**FINAL DRAINAGE REPORT
FOR
STERLING RANCH FILING 3**

Engineering Review

**June 2021
Project No. 25188.02
SP-20-003**

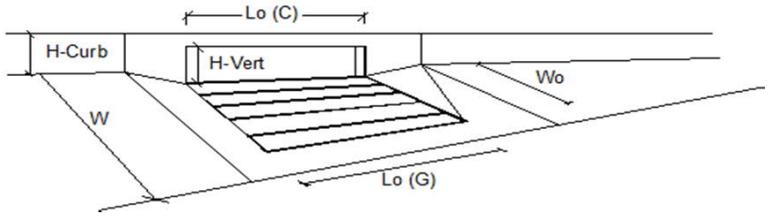
is this correct?
DP15?

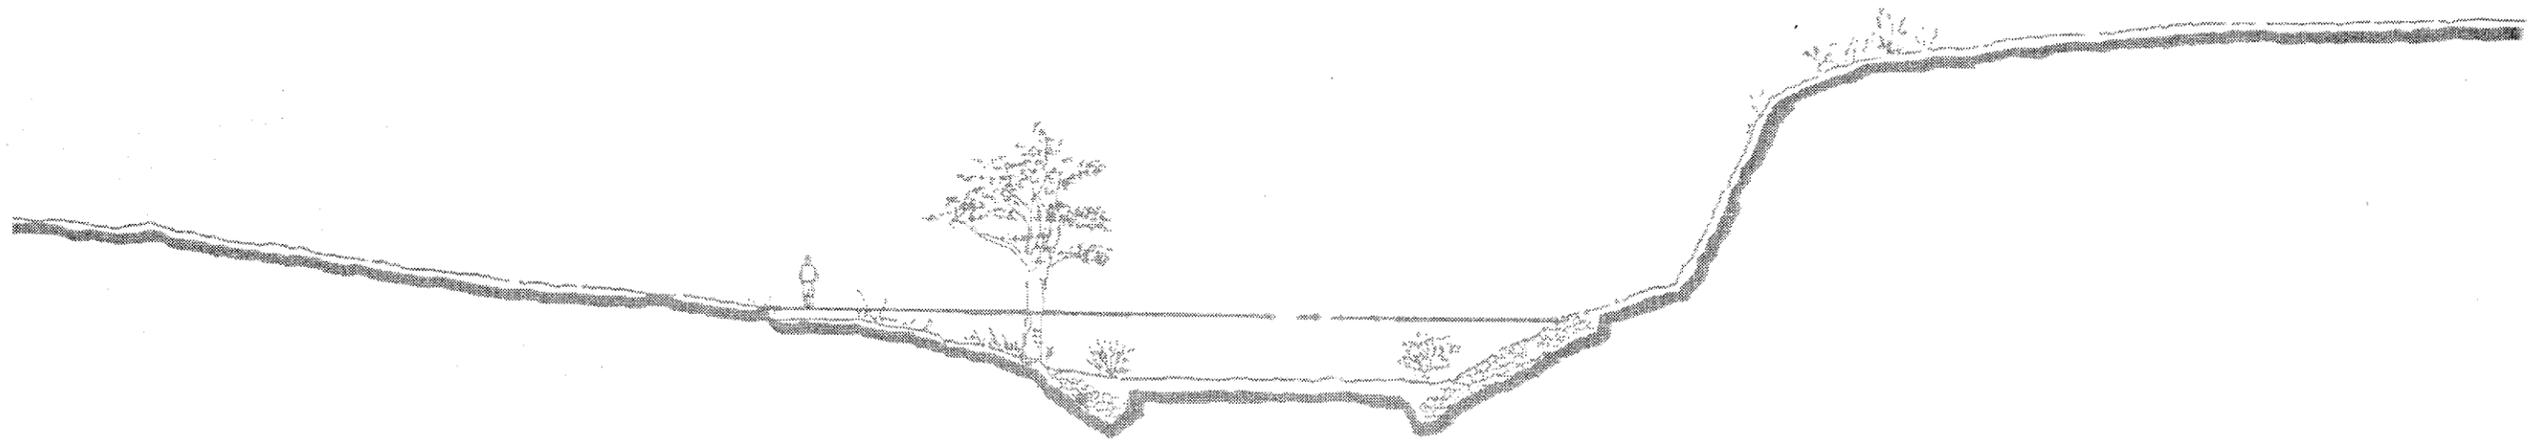
these notes don't
match the
Diameter column.
